## Application for Licence Amendment

<b>Licence Number</b>	L8232/2008/2
<b>Licence Holder</b>	Pilbara Iron Company (Services) Pty Ltd
<b>ACN</b>	107 210 248
<b>File Number</b>	DER2013/001103 & APP-0031697
<b>Premises</b>	<p>Brockman Syncline 4 Mine</p> <p>Legal description –</p> <p>Part of State Agreement Mining Lease ML4SA, General Purpose Lease G47/1232, and part of Miscellaneous Licences L47/153 and L47/141</p> <p>ROCKLEA WA 6751</p> <p>As defined by the Premises map attached to the Revised Licence</p>
<b>Date of Report</b>	5 June 2026
<b>Decision</b>	Revised licence granted

Figure 1: Amended Prescribed Premises boundary and BS4 – BS2 Pipeline corridor

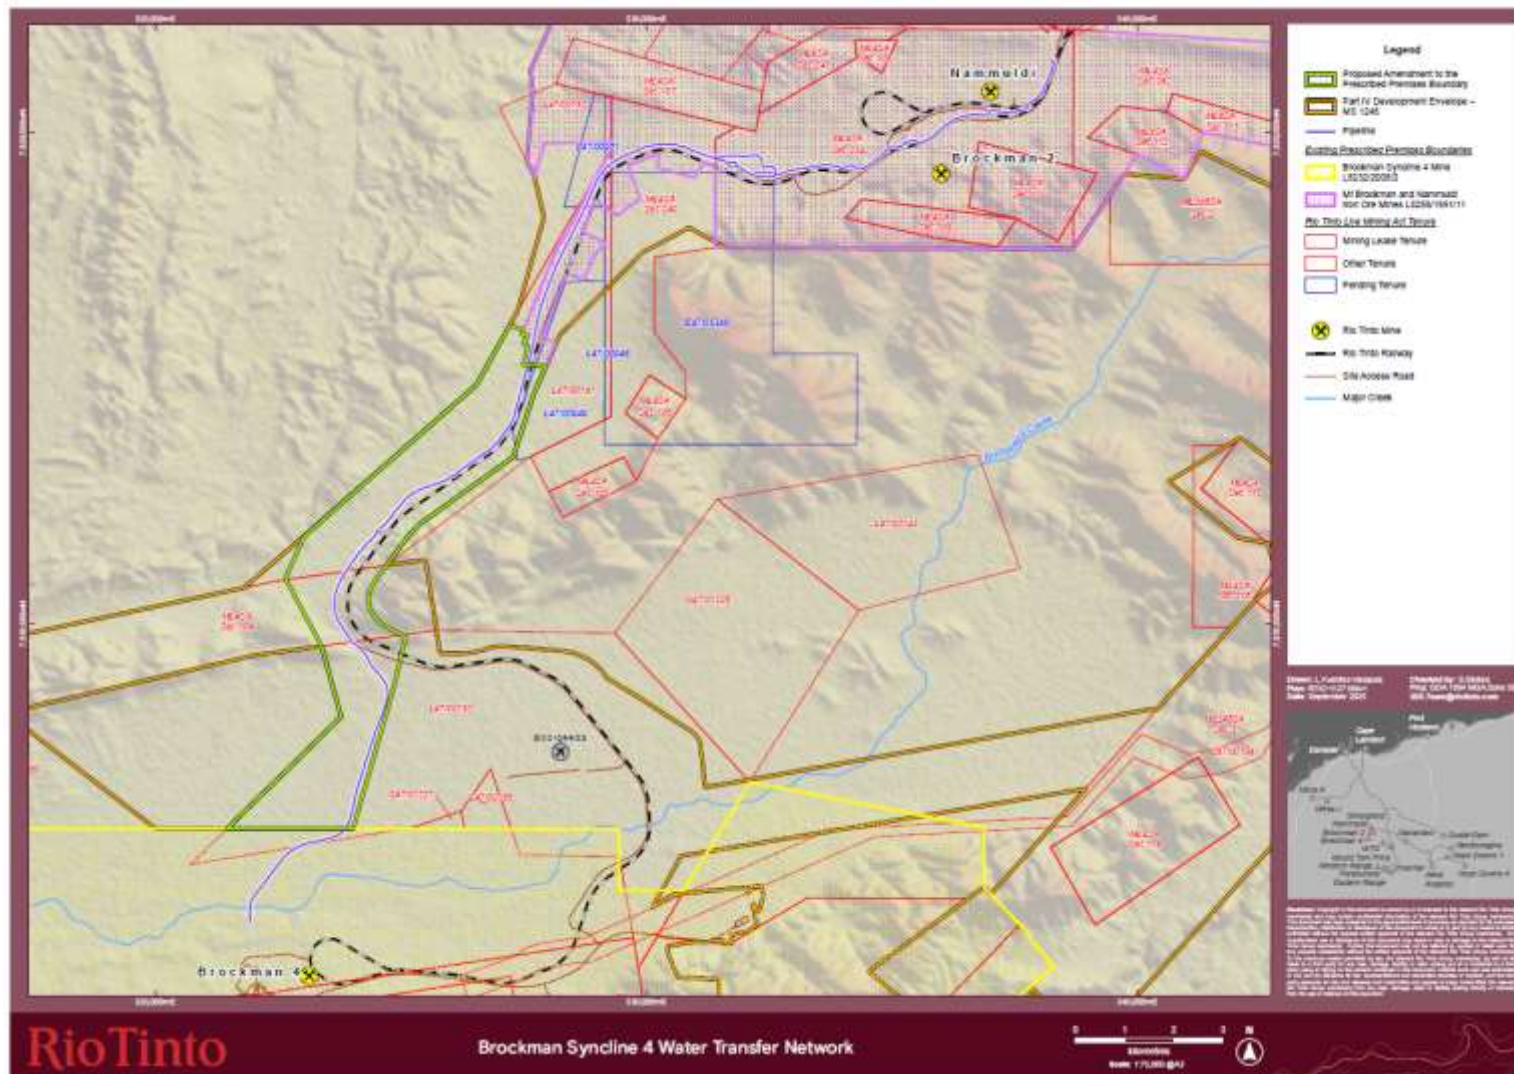
To address this deficit, the Licence Holder proposes the transferring of surplus dewatering water from BS4 to BS2, primarily to support the Nammuldi operations. Surplus water will be conveyed via a proposed 30 km HDPE pipeline (with selected carbon steel sections), designed in accordance with AS 4041-2006 and AS/NZS 4130-2018, for use in ore processing, dust suppression and other operational water needs. The amended prescribed premises boundary, incorporating the BS4 to BS2 transfer pipeline, is shown in Figure 1.

The BS4 to BS2 transfer pipeline transports dewatering water off-site and outside of the prescribed premises boundary for licence L8232/2008/2. The pipeline will exit the premises boundary and will continue onto the premises boundary for licence L5258/1991/10 which is also held by the Licence Holder. Water will be discharged into Nammuldi pit located at BSB2 Hub.
